## CBD & South Eastern Light Rail Project

### Royal Randwick Racecourse submission to Preferred Infrastructure Report

Submitted to Planning and Infrastructure NSW

April 2014

Figure 2: Revised local access arrangements to RRR (Source: PIR)

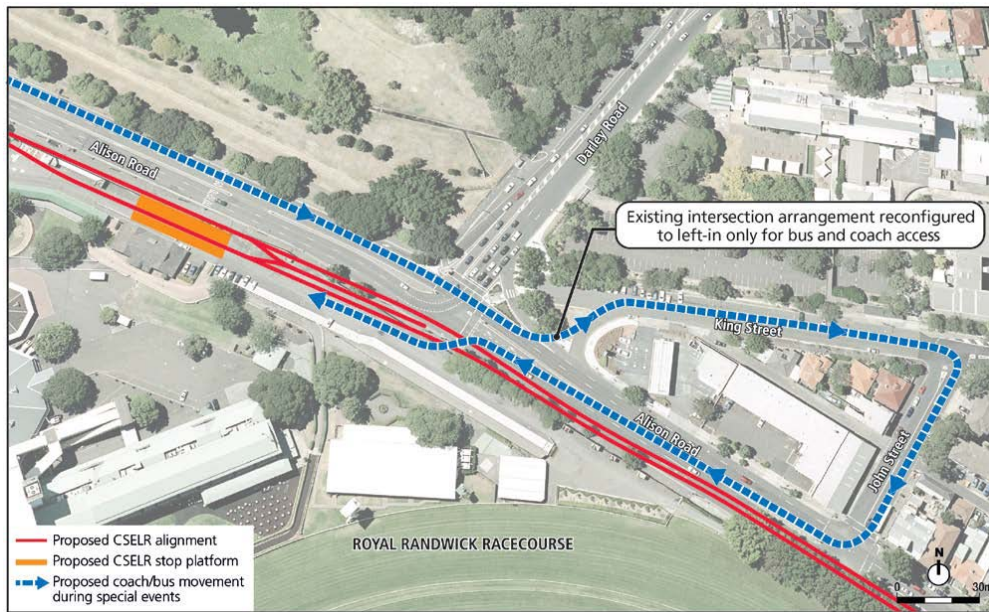
The ATC has undertaken a detailed investigation of the above design change and raises the following issues:

- *Exhibited proposal* - TfNSW acknowledge this proposal was unsafe for pedestrians
- *Busway* – the proposal does not provide sufficient detail for an appropriate area for set down / pick up of patrons to the RRR. Any bus area will need to ensure pedestrian safety at all times as well as resolve potential bus conflict with:

- light rail operations
  - existing traffic along Alison Road
  - traffic entering and leaving the RRR.
  - Pedestrians
  - The event stop
- *Impact on Spectator Precinct* - The buses appear to enter the Spectator Precinct which is likely to result in conflict with the high level of pedestrian movements during both raceday and non-raceday events in this area (this was also the case with the exhibited design).

- *Crossing light rail* – there is insufficient detail provided to demonstrate that buses can cross the light rail in a safe and coordinated manner. This has the potential to create confusion and potential conflict to both light rail and bus operations.

- *Pedestrian safety* – Does not appear to provide appropriate or best practice crowd management or acknowledge maximum crowd numbers and acceptable operations for bus numbers or mode min. In addition, it does not identify mode mix during peak operations or operational management plan.

The revised local access arrangement has merit by providing an alternate access arrangement for eastbound buses to access the RRR. Following consultation with TfNSW, the ATC proposes an alternative solution to address the loss of the existing busway (resulting from the RRR event stop) in conjunction with the proposed local access arrangements for buses as detailed in the PIR. Further details are provided in Appendix 3 and a recommended Condition of approval (A.32)

- Utilises existing signalised intersection at Darley Road and Alison Roads for buses to turn into the RRR
- Enables buses to cross the light rail at a controlled intersection
- Provides a well resolved bus set down/pick up area that addresses pedestrian, traffic, bus and light rail conflicts
- Designed in conjunction with an alternate light rail access to the LRV Stabling Facility and revised Gate 1 entrance to the RRR

Figure 3 – ATC alternative design solution for Gate 1 access and new bus layover area (outlined in **RED**) with buses travelling from PIR revised local access arrangements (outlined in **BLUE**) (Source ATC)

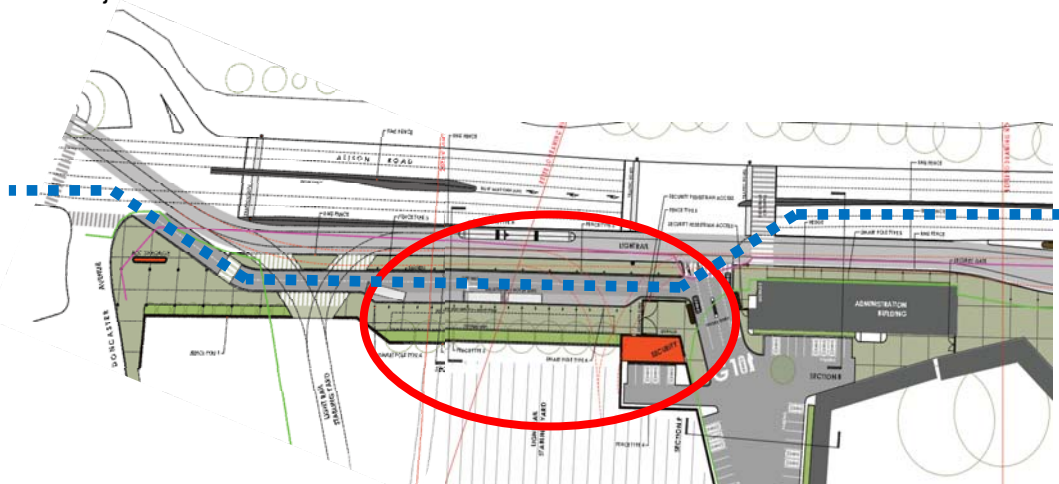
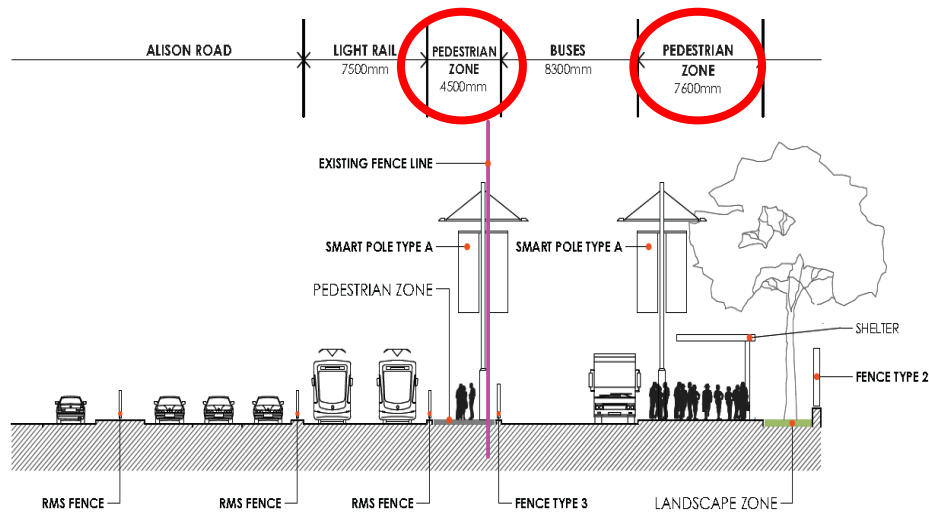
- The design provides a new busway located in conjunction with Gate 1 and entrance to the LRV Stabling Facility. Eastbound buses can travel in the revised local access arrangements as proposed in the PIR and continue westbound into the new busway
- The new busway reduces potential impacts between buses, light rail and pedestrians by providing a dedicated pedestrian zone for bus setdown and pick up
- The new busway will ensure appropriate interaction with the light rail in conjunction with the main entrance to the RRR

Figure 5 – EIS proposed setbacks from light rail to racetrack along Alison Road and track minimised to 1.4m (Source: ATC)

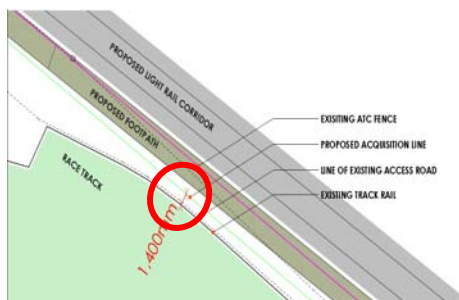
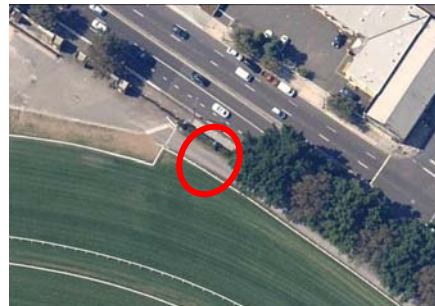
The ATC has previously raised the issue of maintaining heavy vehicle access to the RRR. The proposed light rail alignment along Alison Road is located in close proximity to the racetrack and results in an unacceptable impact on:

- The ability for heavy vehicles to access this part of the RRR; and
- Equine activities, including racedays

It is noted that the PIR amendments will result in additional impacts on the RRR including the removal of the existing dwelling and impacts to existing and proposed access for heavy and light vehicles access to service track for maintenance and the balance of the site and infield (Figures 5-7). The revised design results in the track being reduced from 3.5m to 1.4m.

Heavy vehicle access to the RRR is required daily and is critical to maintain the continuous operating environment for all equine activities and non-raceday events. The proposed Gate 7A accommodates the new Wansey Road light rail stop and provides more efficient access for heavy vehicles to the RRR.

Figure 8 – ATC alternative design solution for a new Cowper Street / Alison Road Intersection for heavy vehicle access for Gate 7A (Source: ATC)

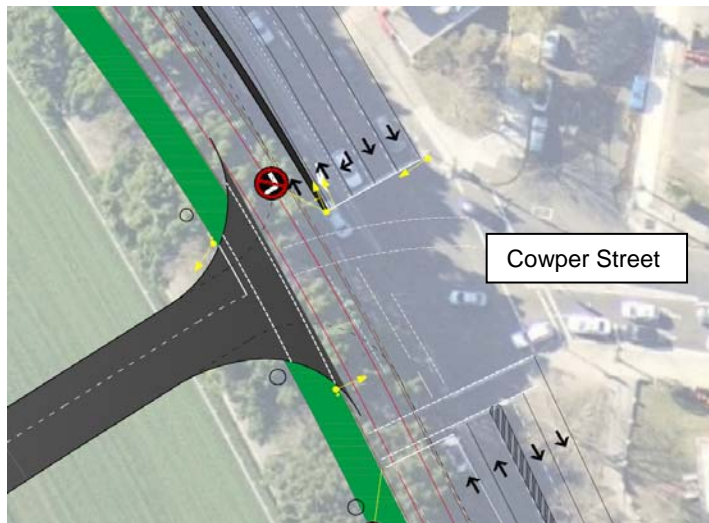
It is considered that this new access at Gate 7A will also reduce impacts on light rail operations through a revised controlled intersection at Cowper Street and Alison Road to allow for heavy vehicle access (Figure 8). The new access will require a re-phasing of the existing intersection to give priority for light rail and ability to allow heavy vehicles to enter and exit the site in a coordinated manner.

Figure 9 – PIR proposed light rail alignment along Wansey Road indicating change of levels impacting on access from Wansey Road to RRR (Source: PIR)

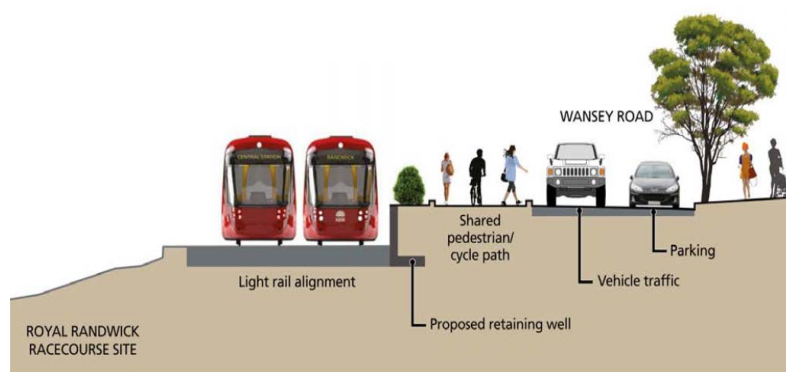
The proposed light rail alignment in certain locations along Wansey Road results in a change of level between Wansey Road and the light rail alignment (Figure 9).

This proposed alignment may impact on both existing and proposed access to RRR along Wansey Road in the following locations:

The ATC recommends that the alignment at Wansey Road be re-graded and amended to maintain adequate access to the RRR along Wansey Road, including a future access at Arthur Street to facilitate the Urban Activation Precinct.

Figure 10 – ATC approved relocation of Gate 10 south along Wansey Road as part of Stables Precinct Approval indicated in **RED** (Source: ATC)

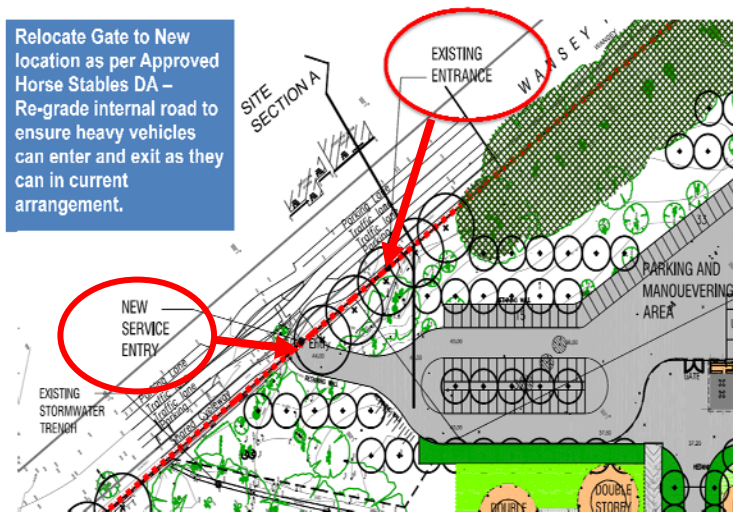
- Gate 10 – this gate is proposed to be re-located as part of the Major Project Approval for the Stables Precinct, including regrading internal road to ensure heavy vehicles can enter and exit as per the current arrangement (Figure 10)
- Gate 12 – this gate acts as the primary access to the existing stables facility and may also facilitate any future Urban Activation Precinct
- Proposed new gate/light rail crossing at Wansey Road opposite Arthur Street to facilitate any future Urban Activation Precinct
